P&A Procedure EPIC Energy – Lindrith #110E

1010' FNL & 1650' FEL, Section 10, T26N, R7W San Juan County, New Mexico, API #30-039-23134

Re: Permanent Abandonment Well: Lindrith Federal 110E

CONDITIONS OF APPROVAL

Proposed P&A

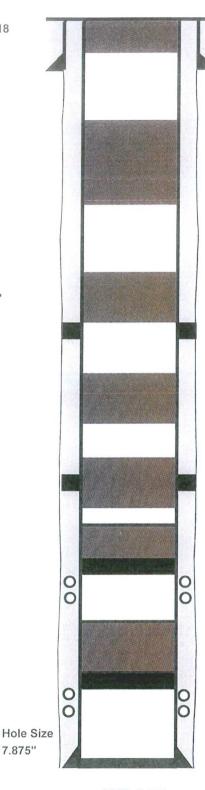
- 1. Plugging operations authorized are subject to the attached "General Requirements for Permanent Abandonment of Wells on Federal and Indian Lease."
- 2. Farmington Office is to be notified at least 24 hours before the plugging operations commence (505) 564-7750.
- 3. The following modifications to your plugging program are to be made:
 - a) Set Plug #3 (5110 5010) ft. to cover the Mancos top. BLM picks top of Mancos at 5060 ft.
 - b) Add a cement plug (3217 3117) ft. to cover the Chacra top. BLM picks top of Chacra at 3167 ft.
 - c) Set Plug #5 (2319 1970) ft. to cover the Picured Cliffs and Fruitland tops. BLM picks top of Pictured Cliffs at 2269 ft. BLM picks top of Fruitland at 2030 ft.
 - d) Set Plug #7 (293 0) ft. to cover the surface casing shoe. Surface casing shoe at 243 ft.

Operator must run a CBL to verify cement top. Submit electronic copy of the log for verification to the following addresses: jwsavage@blm.gov Brandon.Powell@state.nm.us

H₂S has not been reported in this section, however, very high concentrations of H₂S (2000 ppm GSV) have been reported in wells within a 1 mile radius of this location. It is imperative that H2S monitoring and safety equipment be on location during P&A operations at this wellsite.

You are also required to place cement excesses per 4.2 and 4.4 of the attached General Requirements.
